ISO/TS16949 REGISTERED TB-009 • July 2017

No-Slack® Top Plate Installation

This Technical Bulletin supercedes Technical Bulletins TB-0293 and TB-001. It covers the replacement of an existing Fontaine No-Slack® 5000 & 5092 series fifth wheel with the new No-Slack® Top Plate (both the standard and air actuated).

Figure 2

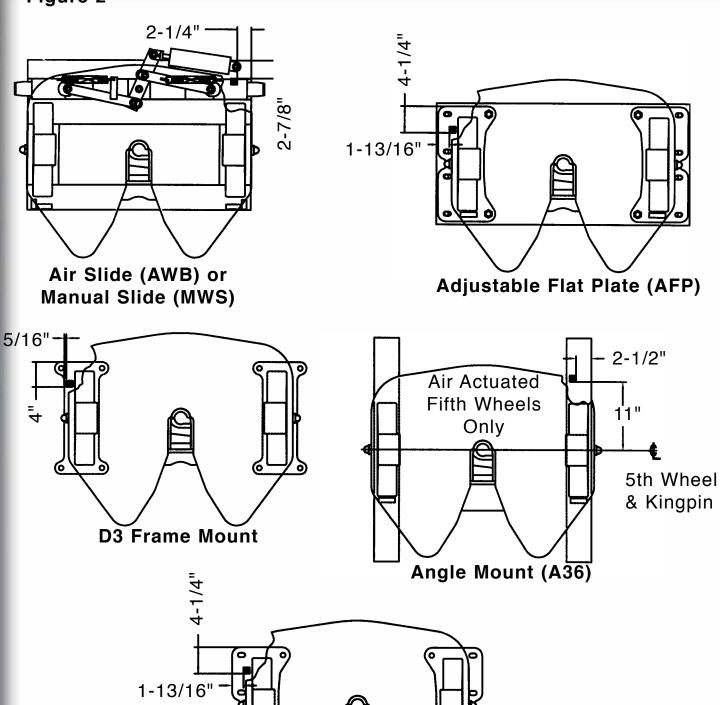
Install your No-Slack® and locate the new rocker block as shown in Figure 2 for your model fifth wheel.

With your No-Slack® installed, locate the new rocker block as shown in the various model configurations in Figure 2 (page). Tack weld the block and tilt the fifth wheel forward to make sure it contacts the new rocker block and clears all parts of the locking system. Check and make sure there is no interference with the air cylinder (if air operated fifth wheel) or the latching mechanism in a slide. Weld the rocker block in place.
